STAFF REPORT

RE: **Key West Historic Seaport (permit application # T18-8977)**

FROM: Karen DeMaria, City of Key West Urban Forestry Manager

An application was received requesting the review of a conceptual landscape plan in association with the proposed renovations at the Key West Historic Seaport area. This review will be discussed in stages.

#48

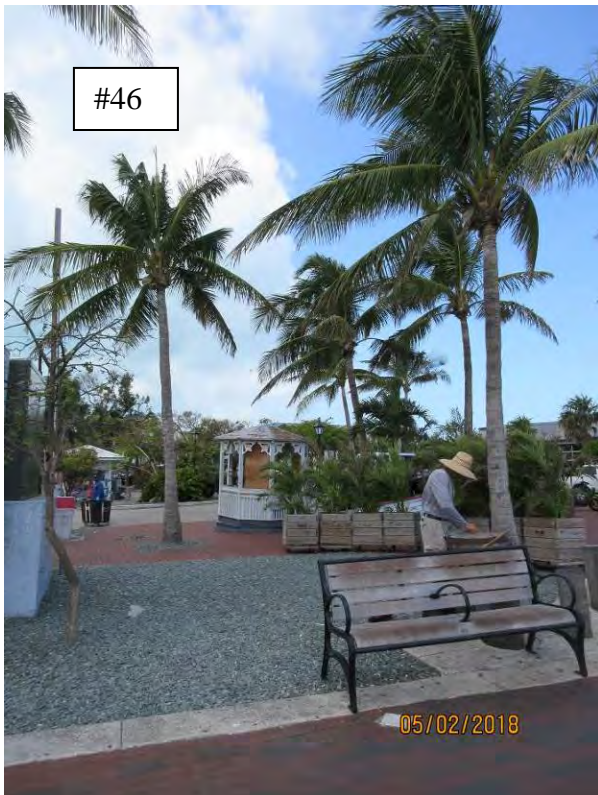
Why do Palms #3, 4, 5, and 6 need to be removed? Transplanting may cause a mess and a great disturbance to the area.

Same for why palms #7 and 8 in that same line of palms, are slated for removal?

Palms #46 and #48 if they can not remain, should be transplanted.

Palm #38 is too tall to be transplanted and due to its condition, would be a candidate for removal.

Geiger tree #47

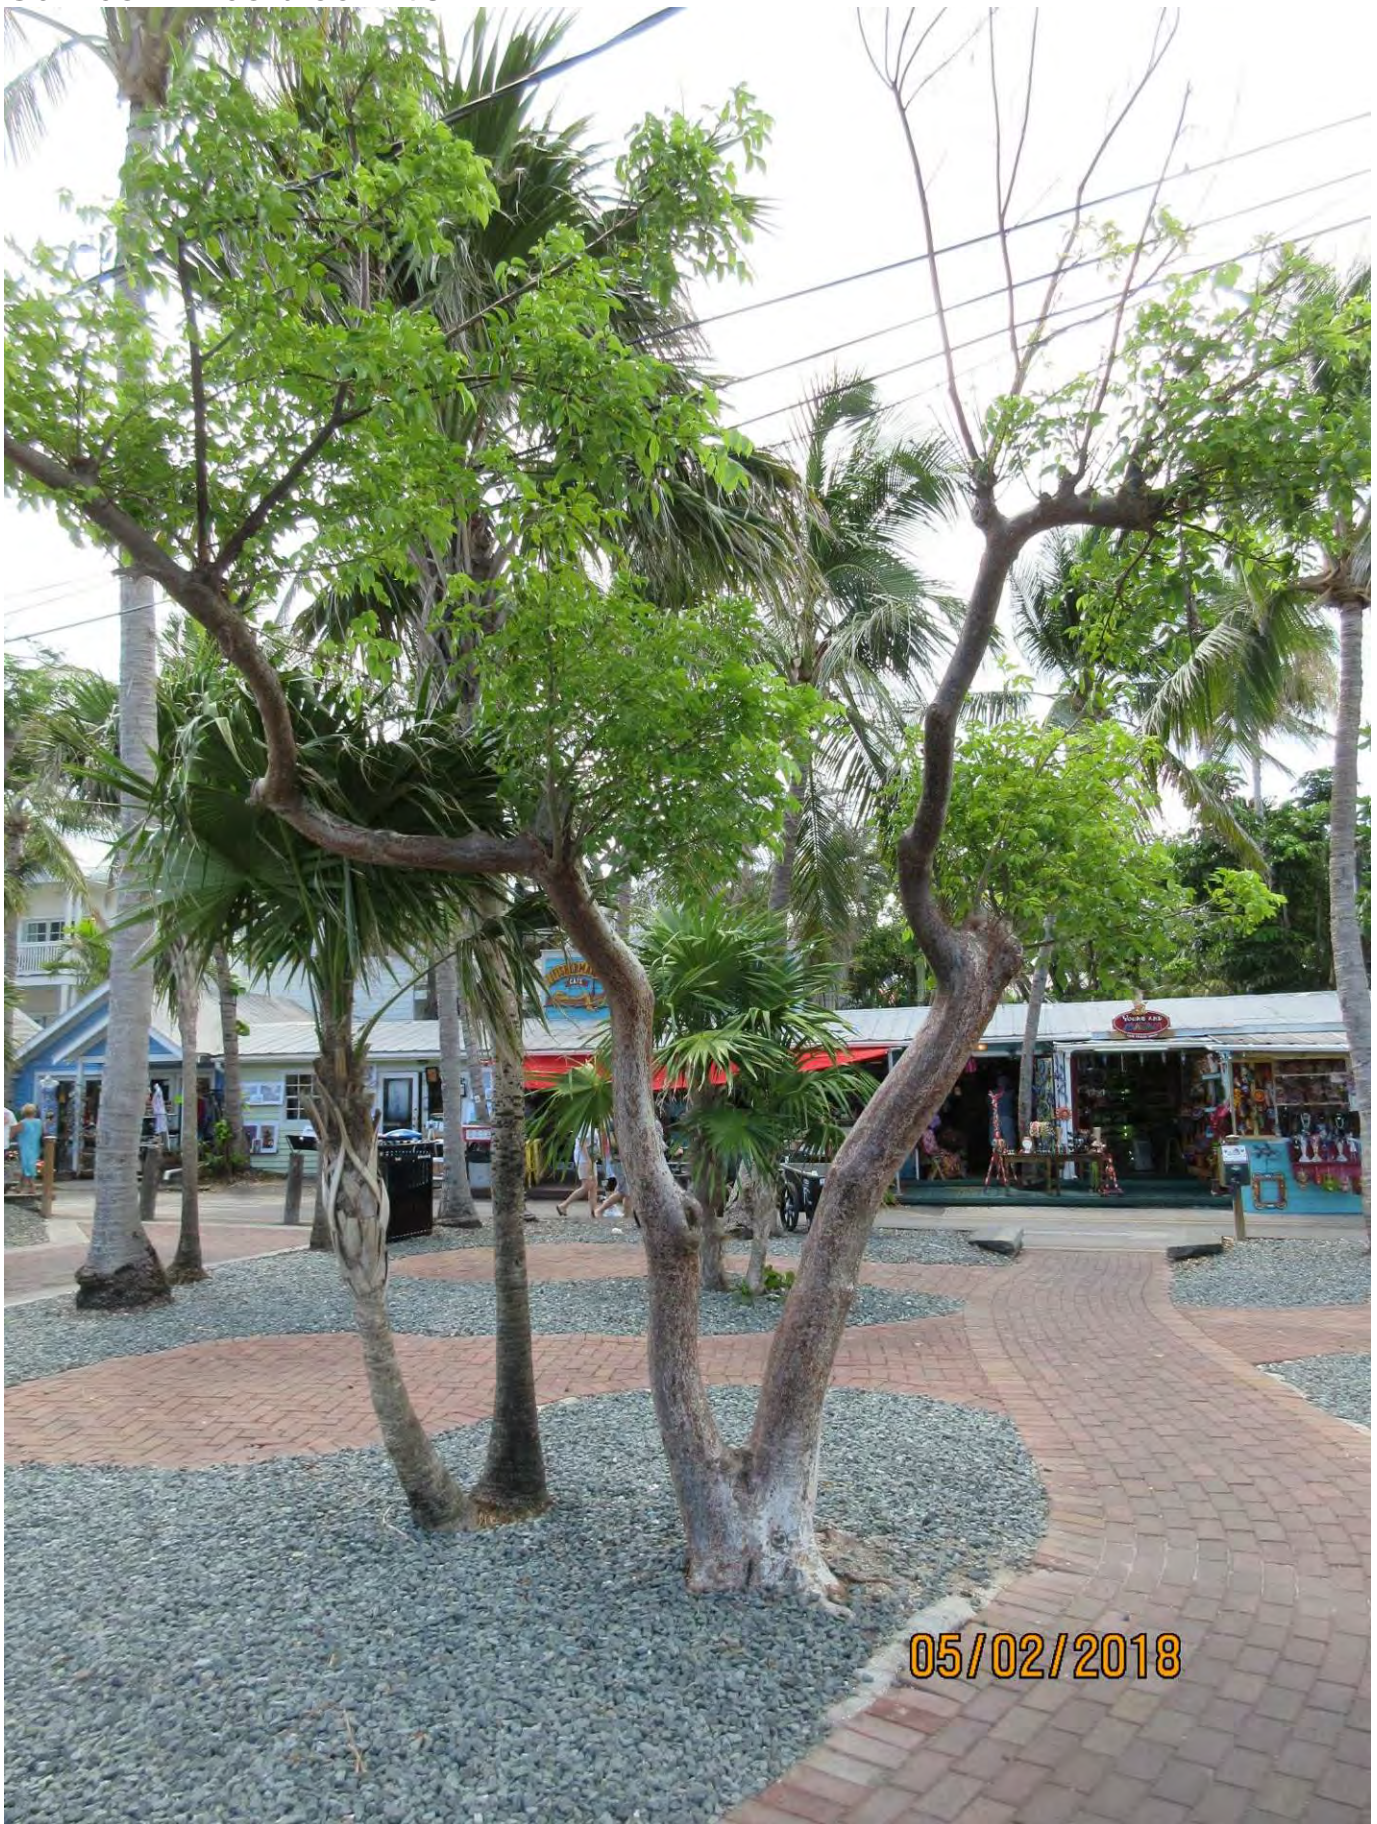
Diameter: 6.2"

Location: 70% (planted close to utility box)

Species: 100% (on protected tree list)

Condition: 50% (fair to poor, poor structure-decay)

Total Average Value = 73%

Value x Diameter = 4.5 replacement caliper inches

Area #2 William Street Plaza

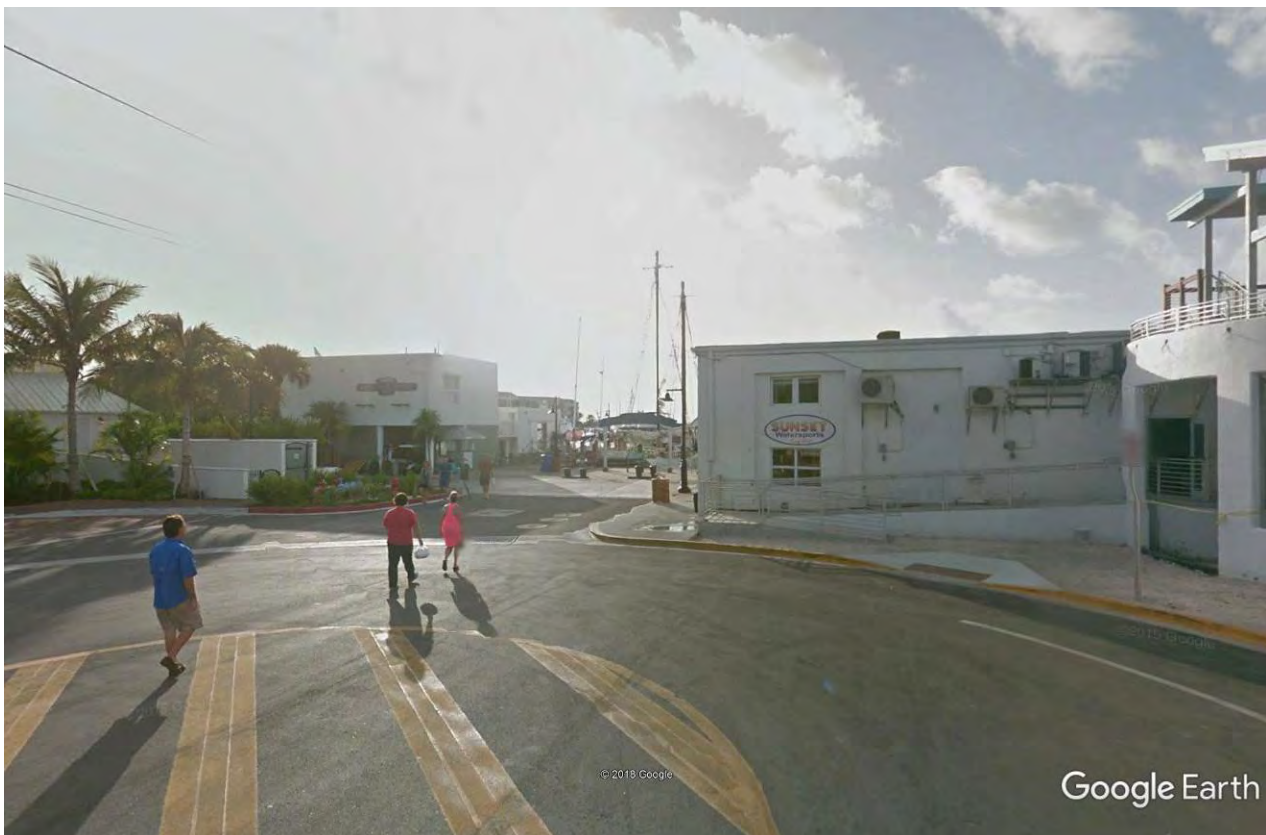
These are some of the Thatch palms that are to be transplanted (where to?).

These Christmas Palms are proposed to be removed. It appears that shrubs will be replanted in this area. Do not recommend removal of these palms. Why do they need to be moved from this area? At the very least, transplant these trees to another location, either in the area or a street planter in old town.

This Thatch Palm is not noted on the plans but is in the project boundaries.

Only shrubs and groundcover are to be added to this proposed work area. Do not recommend the planting of saw palmetto.

Area #3 Margaret Street Plaza

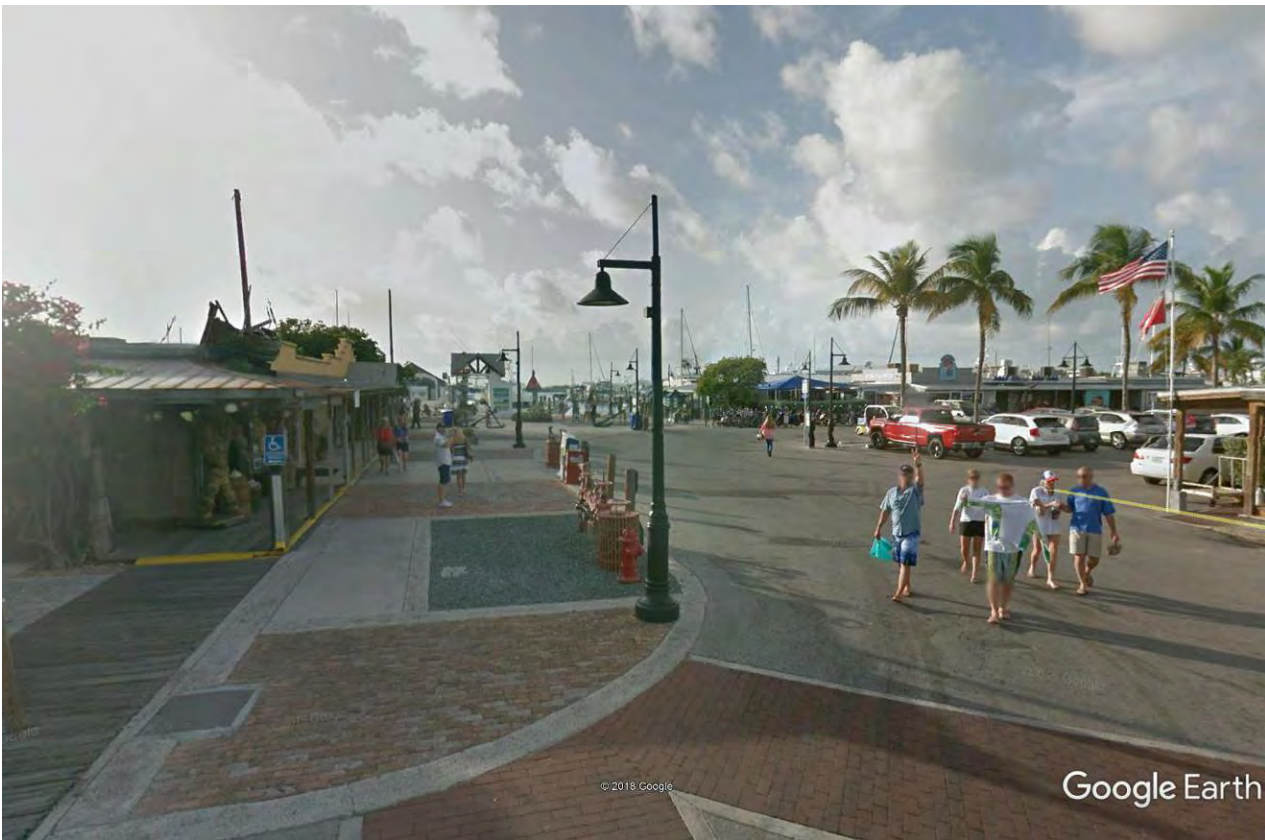
The landscape plan proposes to add tree planters with Pigeon Plum trees along the Margaret Street store front area. Would possibly like to see two or three different species of trees instead of all seven new trees being the same species or is there a certain look for the area that is being developed? The landscape plan says Thatch palms will be transplanted into this area. Where from and where on the plans?
